**HSCC (INDIA) LIMITED**  
(A Subsidiary of NBCC (India) Limited)  
(A GOVERNMENT OF INDIA ENTERPRISE)

**AMENDMENT No.– II**

**Project Name:** Tender for “Construction of Medical College, Residential Campus and Allied Buildings for AIIMS Rajkot and their Maintenance during Defect Liability Period on Design, Engineering, Procurement and Construction (EPC) basis”

**A. Reply to Pre Bid Queries raised by bidders during pre -bid meeting held on 06.01.2020 at HSCC, Head Office, Noida**

DATE  
26/12/2019  
DWG. NO.-  
A.- SURVEY 02 (R)

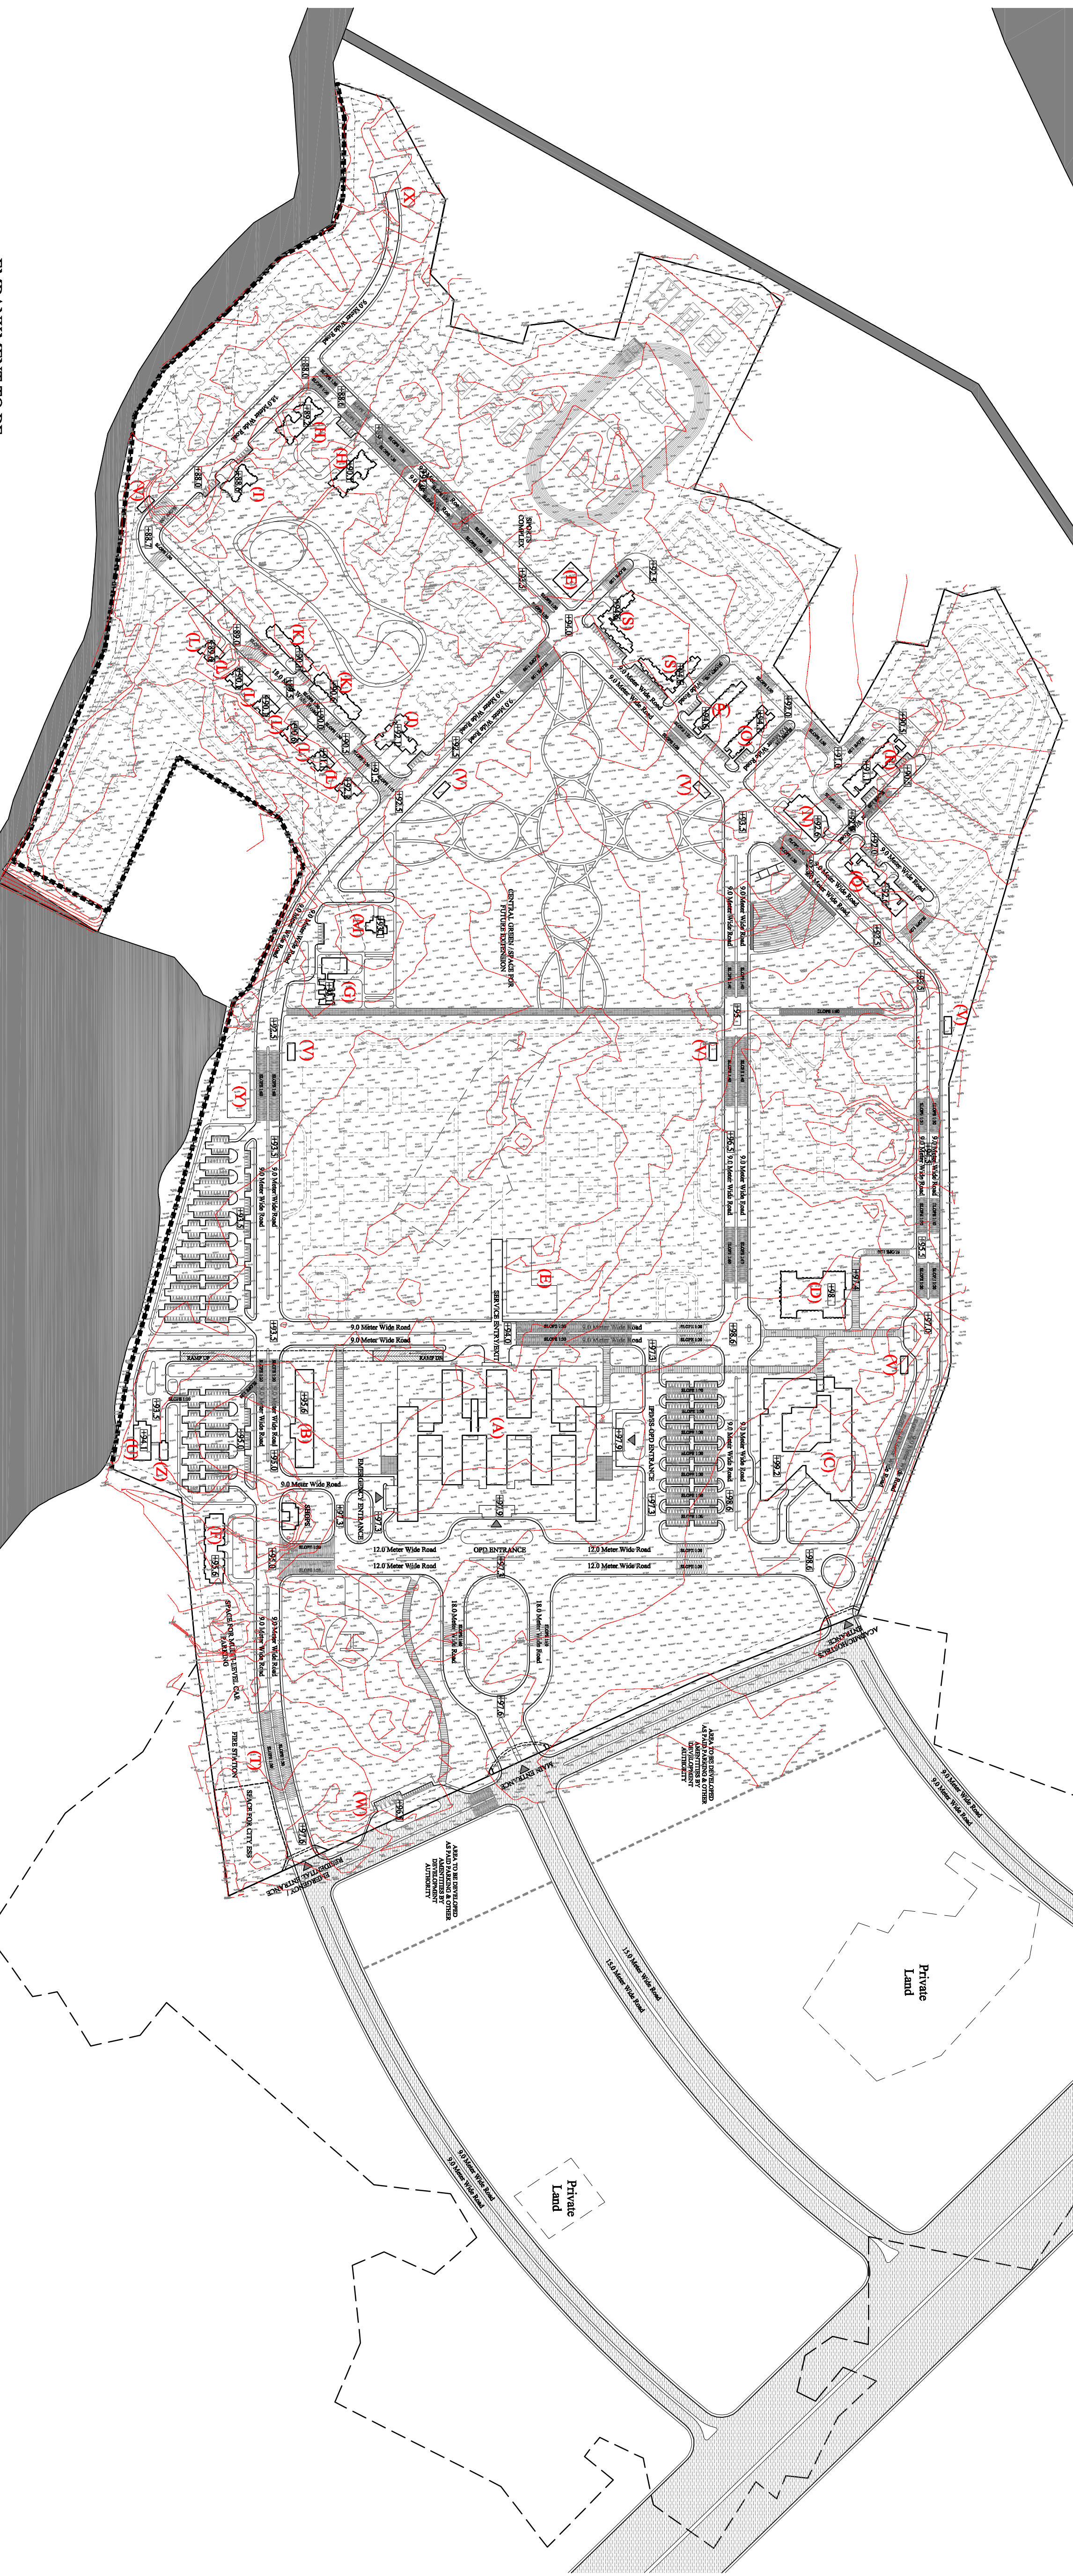
14.	Technical point			Drawing No A survey-02 site plan with survey line shows service lock 'E' at two location with rectangle building footprint , whereas drawing no A-01 site layout plan shows service block 'C' at one location with 'C' shape building footprint. Please clarify scope of work for service block.	Drawing No.A, Survey -02 Site Plan (revised) enclosed. For Service Block area 467 sqm. (Single storey building) shall to be considered.

16.	Technical point			Scope of work for Medical college, Residential and Allied building at page no 2 of 10 name of building and configuration 1-6 service block(6), 467 sq.mt is mentioned. Please provide the drawings Plan, Elevation and section for the same. Also, please revise the area statement which is not mentioned in Service Block drawing.	Service Block area 467 sqm. (Single storey building) shall to be considered.
